Stormwater Division

SKIFFES CREEK TERRACE
STORMWATER MANAGEMENT FACILITY
Scale: 1 inch = 300 feet (Approx.)

Re: Skiffes Creek Terrace
Stormwater Management Facility (SC 001)

James City County Environmental Division
Stormwater Management / BMP Inspection Report
Detention and Retention Pond Facilities

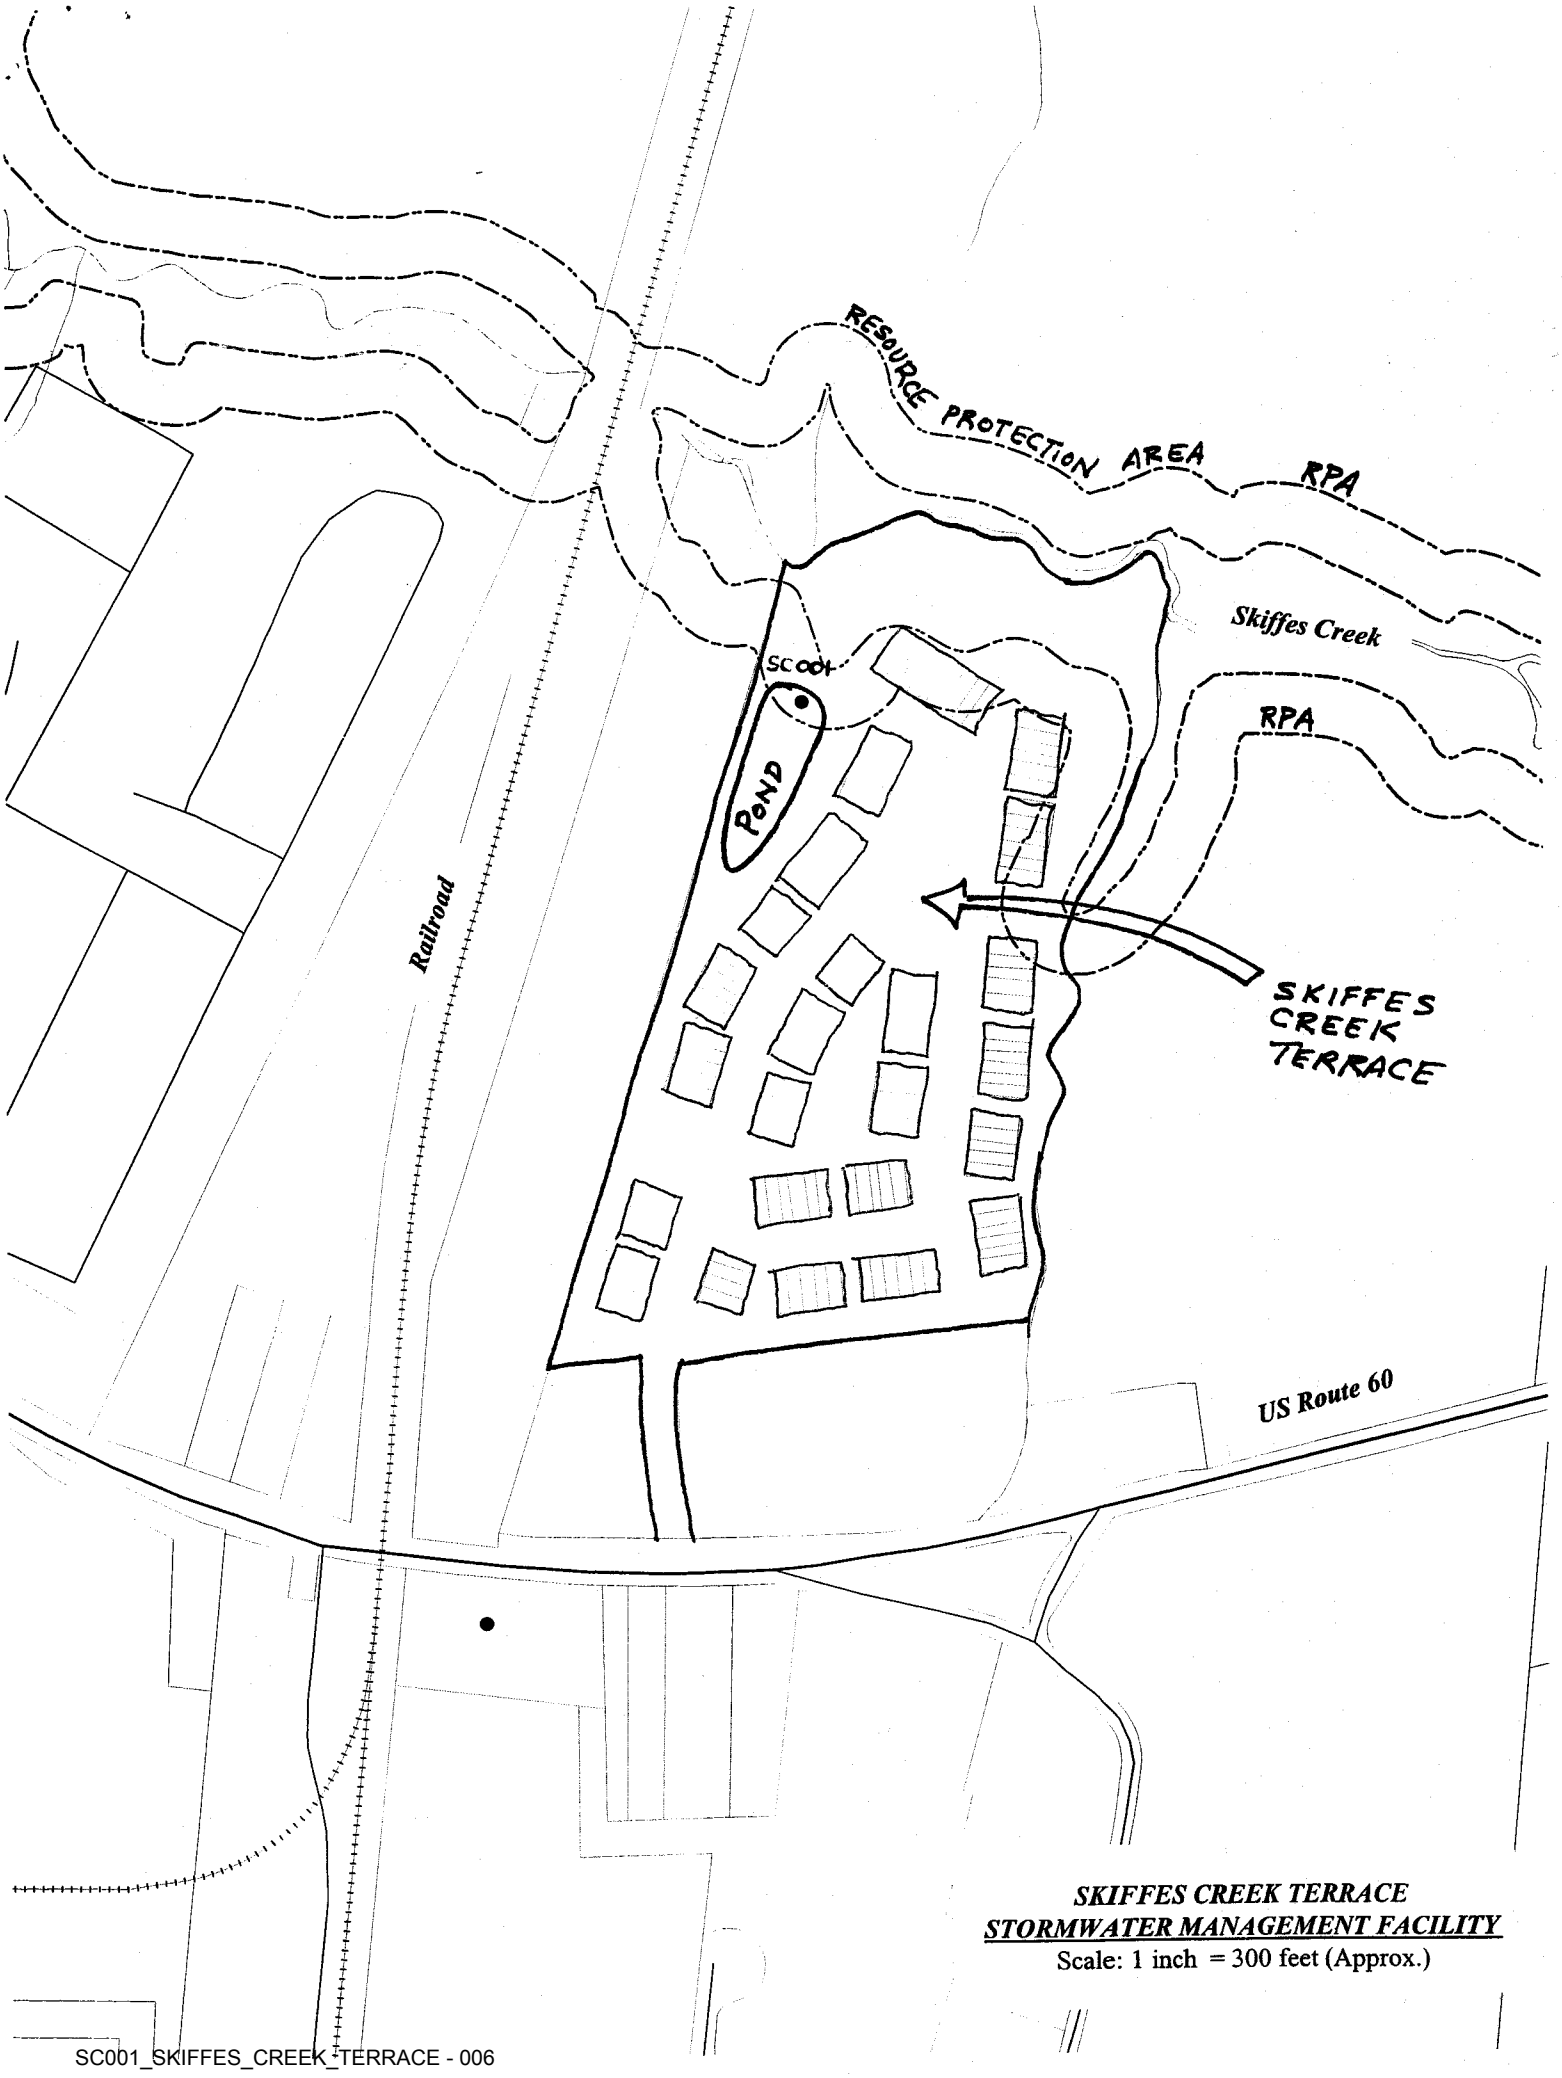
Based on field observations, the facility appears to be in satisfactory condition for its age and trash removal and maintenance efforts on the upstream face of the dam embankment are performed routinely. However, the facility is in need of regular (routine) maintenance typical of most wet pond facilities. From our perspective, main concerns were the presence of tree vegetation on and along the downstream toe of the engineered fill embankment, vegetation and tree growth along the concrete emergency spillway, sediment and vegetation at the paved channel inflow into the pond and erosion at the fence near the storm drain inflow at the midpoint of the pond (between Units 30 and 31).

The pond's embankment is north of the water pool where the riser pipe is located. Heavy tree and ground vegetation cover most of the downstream embankment and lower portions of the emergency spillway. These trees should be removed. Saturated roots mats combined with high wind can cause trees to overtop and accelerate soil erosion and embankment failure. We recommend that the trees be cut to ground level and be maintained in that fashion as to not disturb root systems that may already be extensive. Efforts should be made to establish a good low-maintenance grass covering to replace the current tree covering, similar to that on the upstream face of the dam embankment. Also, vegetation and tree growth needs removed from along and within the joints of the concrete emergency spillway.

The pond has three primary inflow locations. One is a concrete open channel at the east side of the dam embankment (across from Unit 37), one is a storm drain located at about midpoint of the water pool (between Unit 30 and 31) and the last is a storm drain located at the back (rear) of the pond near Unit 21. Vegetation and tree growth in back areas surrounding the normal water pool may be removed or left in place at the preference of the owner, depending on whether a dressed or natural look is preferred. Access for future maintenance around the pool should be a consideration because at some point in the future access may be required to the two storm drain pipes that flow into the pond. The concrete open channel at the end of the parking area (across from Unit 37) is in need of immediate attention. Sediment and tree vegetation at the end of the channel needs removed as to not restrict inflow of stormwater into the pond. Clearing and sediment removal is only needed in the immediate vicinity of the end of channel.

Sediment was measured about one foot deep at the riser pipe and about 6 inches deep at the storm drain inflow point at the middle of the pond. Although cleaning of sediment from the bottom of the pond does not appear immediately necessary, it may be necessary sometime in the near future. Also, due to the concrete cap over the pond's riser pipe, the inside of the riser could not be observed. Although the exterior appeared acceptable and there were no signs of malfunction, future consideration should be given to hiring a contractor to remove the concrete lid and inspect, clean and perform general maintenance on the inside of the riser pipe and 12-inch sluice gate located at the bottom.
